**CITY OF BOULDER  
BOARD OF ZONING ADJUSTMENT  
MEETING AGENDA**

**A. Docket No.: BOZ2024-00002**

**Address: 624 Maxwell Avenue**

**BOZ2024-00002**

(N) - REAR/SOUTH ELEVATION

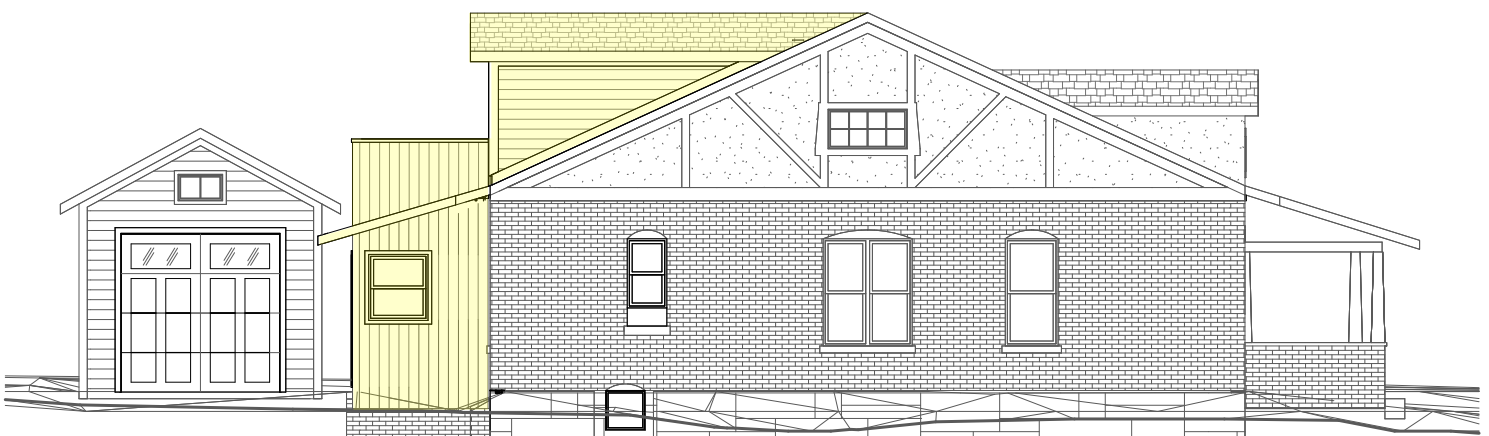
I do not have much issue with the proposed side yard set backs but I ask that the balcony over the existing back porch footprint, which encroaches significantly into the rear yard set back be denied. The applicant's rational for "needing" the balcony appears to be a misinterpretation of the relevant code.

I believe this is an incorrect interpretation of the code for egress. This requirement can be met with windows that meet the minimum requirements set forth in the following link or with a much smaller "Juliette" balcony.  
<https://bouldercolorado.gov/sites/default/files/2021-03/guide-emergency-openings.pdf>

From a safety perspective, it would likely be easier to exit a window, walk to the edge of the roof, hang over the edge and then drop. A balcony complicates egress in that there is a much higher drop from top of rail to ground and minimal roof area to facilitate a lower drop.

**I question the rationale for requiring the balcony and ask that this encroachment into the rear setback be denied and this detail be sent back to Design Review.**

The balcony included in this proposal does impair the use and enjoyment of my home which is immediately adjacent to 624 Maxwell, separated only by a public alley with each property having very narrow side yards. I am one of the 2 neighbors that did not sign off on the letter presented to us by Mr Barkhorn. My neighbor who did sign, described as the "closest" neighbor, is a bit closer but their's is a 1 story house and 624 Maxwell has a side yard big enough for fencing and screening with vegetation.

This proposal substantially increases the existing encroachment with the addition of the balcony over the existing back porch. The proposed balcony aligns with my small 2 story back porch (done well before any code requirements) and will be clearly visible from my second story windows. My bedroom is on the second level and in close proximity to the new balcony. Sound carries in this neighborhood and we still often have our windows open through the night to cool our homes. My peace and quiet will be diminished.

**I can not support this project in its entirety and ask that you deny the balcony that encroaches into the rear set back and will significantly diminish my reasonable use and enjoyment of my property..**
